SERVICE BULLETIN SPSB008

SUBJECT: RELEASE CABLE TRIMMING

STATUS: MANDATORY INSPECTION

SUN PATH PRODUCTS, INC MAIN CANOPY RELEASE HANDLES (PART NUMBER JP068-1) DELIVERED WITH SYSTEMS WITH DATE OF MANUFACTURE JANUARY 2009 THROUGH PRESENT (FEB 2013). IF THE DATE OF MANUFACTURE OF THE HARNESS/CONTAINER SYSTEM IS BETWEEN 1/2009 AND 2/2013, THE CABLE LENGTHS MUST BE INSPECTED.

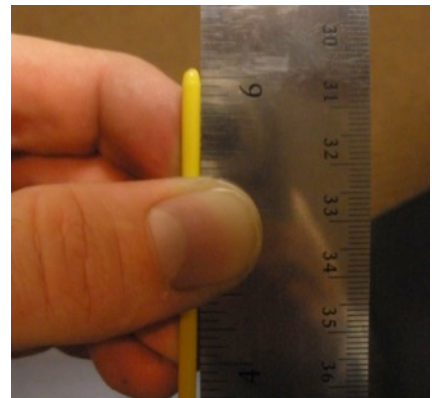
2. Ensure that the release handle is installed; Velcro mated and is all the way up to the top of the inside of the pocket.

3. Remove any slack in the cables by pulling upward on both sides slightly. (A short tug/or pull on the cable end should take out any slack that may be in the system)
4. Place the rig on the ground or chair and allow the yoke area to relax and ensure your housings are seated/routed as if being worn. Specifically the loop area on the left side behind the main ring cover.
